OTWAY WATER BOOK 42

**Response to Jacobs' Draft Report
2016-2017 Technical Works Program**

Barwon Water
Yeodene Swamp Study
Final draft
9 November 2017

Figure 3. Details taken from the DSE & CFA fire report of the 2010 Big Swamp Wetland fire.

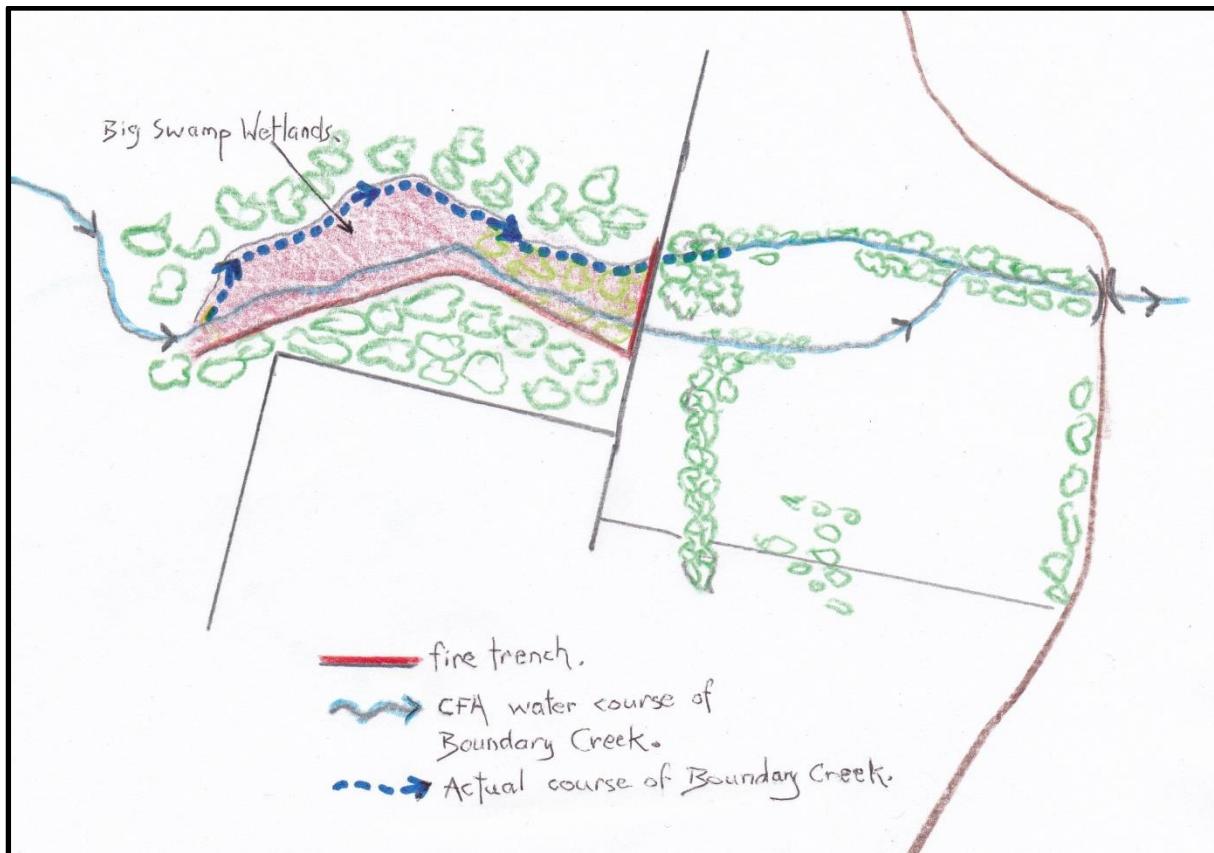
An addition made to this CFA map is the actual course of Boundary Creek that flows around the northern perimeter of the Big Swamp Wetlands. As with so many computer generated maps the true course of many small streams such as Boundary Creek are approximations. However, by not conducting on ground work such maps can cause serious miscalculations to be made. Not knowing that Boundary Creek flows around the Big Swamp Wetlands is such a case.

4. Figure 0-1-1 wrongly depicts the flow of Boundary Creek flowing into the Big Swamp. The flowpath in Boundary Creek follows the contour of the lowest point hugging the northern boundary of the swamp(see Figure 3, page 5, above). Neither does the water pool as depicted in the diagram. This inaccuracy has been an ongoing debate that could easily be resolved if the authors actually walked the creek path. It would be quickly seen that the bed of the creek is below any chance of the flow dissipating into the swamp at the western end except in exceptionally wet periods. Since 2007 I have yet to see this event to take place.

Figure 4-2 Schematic cross sections of eastern end of Yeodene Swamp

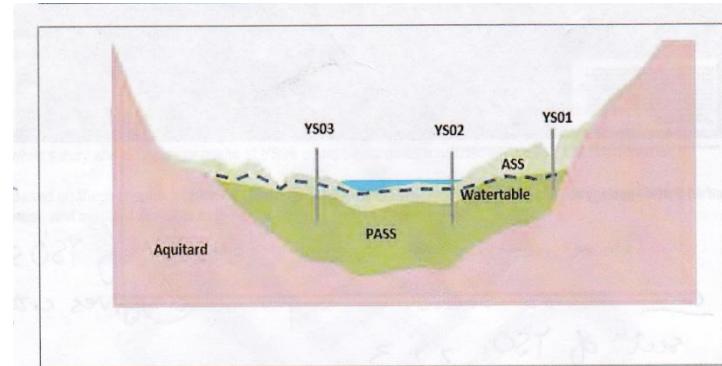
Creek Catchment, knowing where the aquitard finishes and the LTA starts in relation to the Big Swamp Wetlands is critical. Not having assayed the greater majority of the wetland ensures any decision is based on pure assumption and guesswork.

The schematic type cross

sections of the eastern end of the Big Swamp Wetlands (see Jacobs’ Figure 4-2, above) needs to be duplicated throughout the wetlands. Why a cross section between YS04 and YS05 has not been done, is a puzzle, as is why there is no mention of Actual Acid Sulfate Soils in these schematic cross sections.

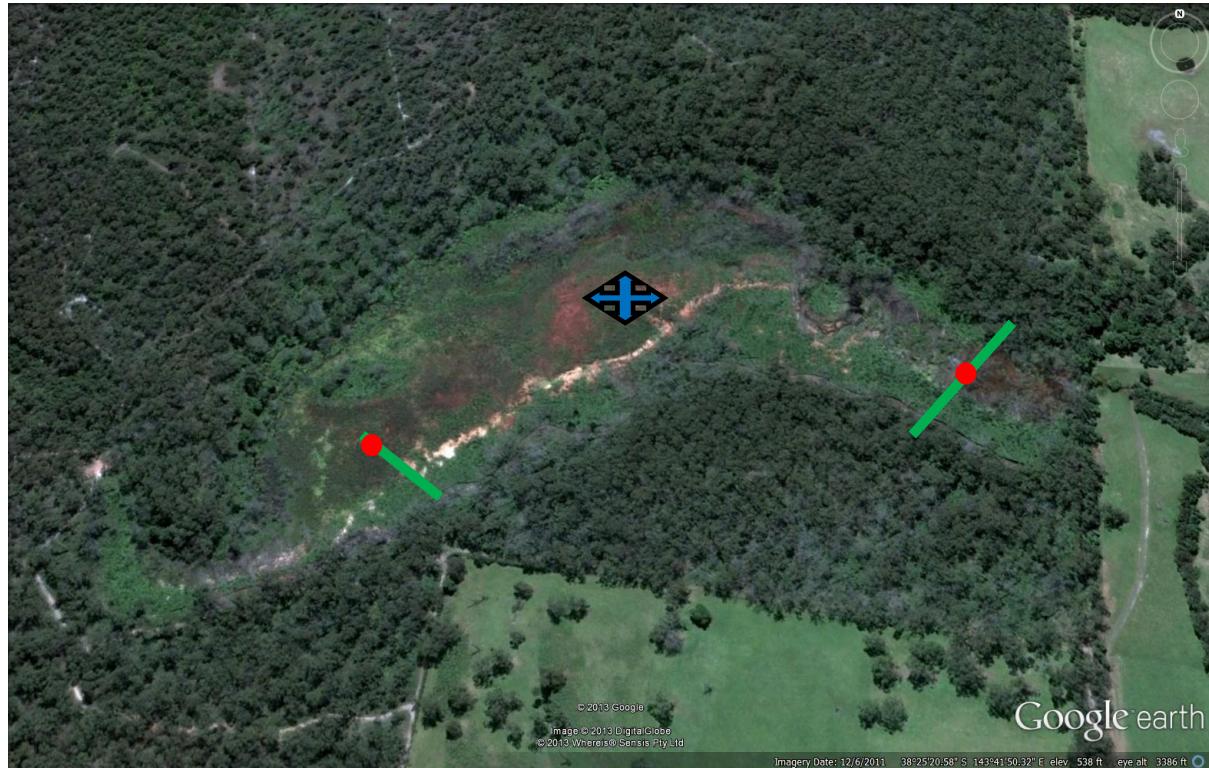
The reference to the centre of the swamp on page 40 is very misleading (see red dots below, page 27). The blue cross would be closer to the centre of the swamp.

Jacobs also wrongly assumes that the red dot areas are both the most susceptible sites to inundation. In 9 years I have never seen the wetlands to

the west inundated. The area marked with the blue cross has never been inundated through this same period.

APPENDIX TWO.

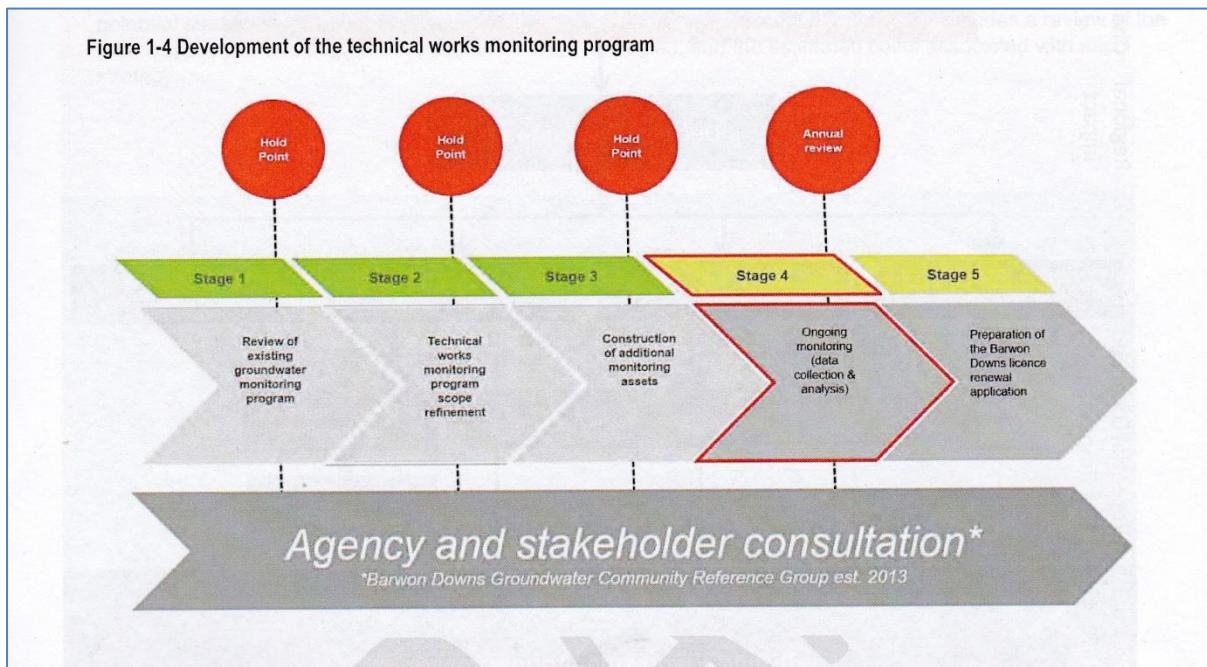
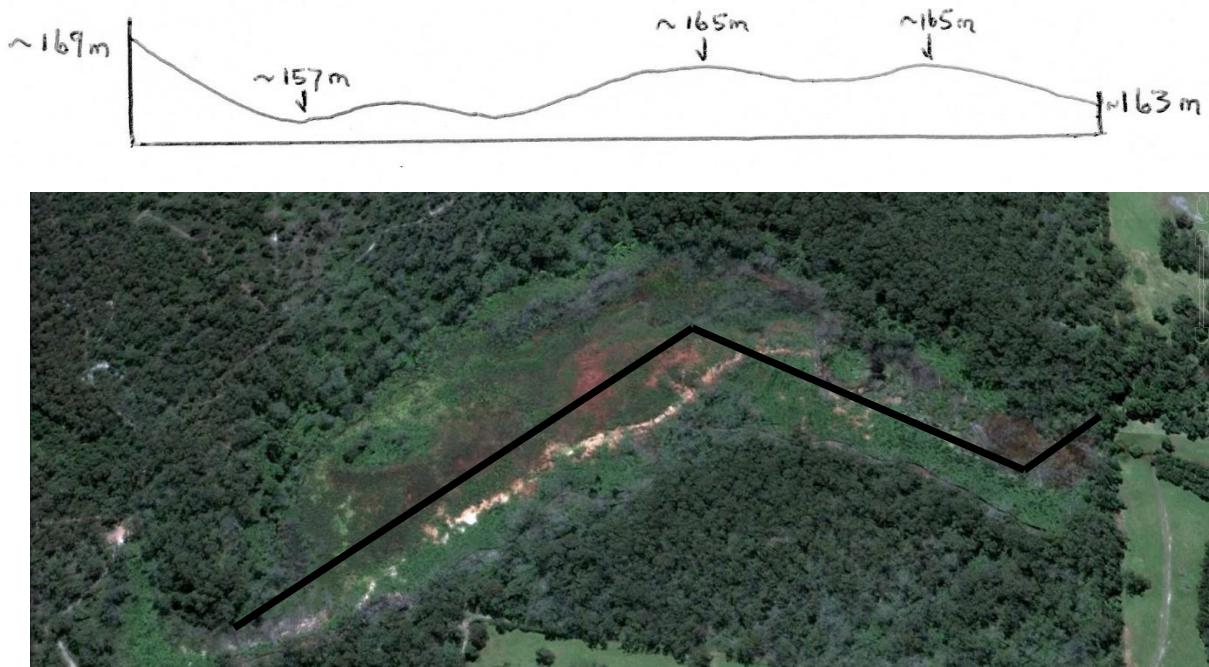
When the six options for the remediation of the Big Swamp were being presented to the Barwon Downs Groundwater Community Reference Group meeting, it was stated by Jacobs staff that the elevation of the Big Swamp Wetlands from front to back was eight metres.

This was taken at face value and resulted in the sketches and comments found on pages 4 and 36. However, after having thought that Book 42 was finished a colleague was showing me some aspects of Google Earth which lead to looking at the Big Swamp Wetlands elevation profile. Surprise. Whatever the accuracy of the AHD levels displayed on Google Earth, it was quite obvious that some considerable doubt should be placed upon a gradual eight metre elevation between the front and back ends of the swamp.

The sketch below is by no means 100% accurate but it is a close representation to the elevation profile found on Google Earth. The Big Swamp Wetlands has

many dips and rises further emphasising how little is known about the wetlands (see pages 13 – 15 for a list of unknowns.). In fact, what this topsy turvy profile suggests, as discussed on pages 8 and 9, is that the Big Swamp contains quite varied and distinctly different vegetation and water dependent areas.

Part of the swampland is lower than both the entrance and exit of Boundary Creek to the area. Much is to be learnt before any form of successful remediation is possible.
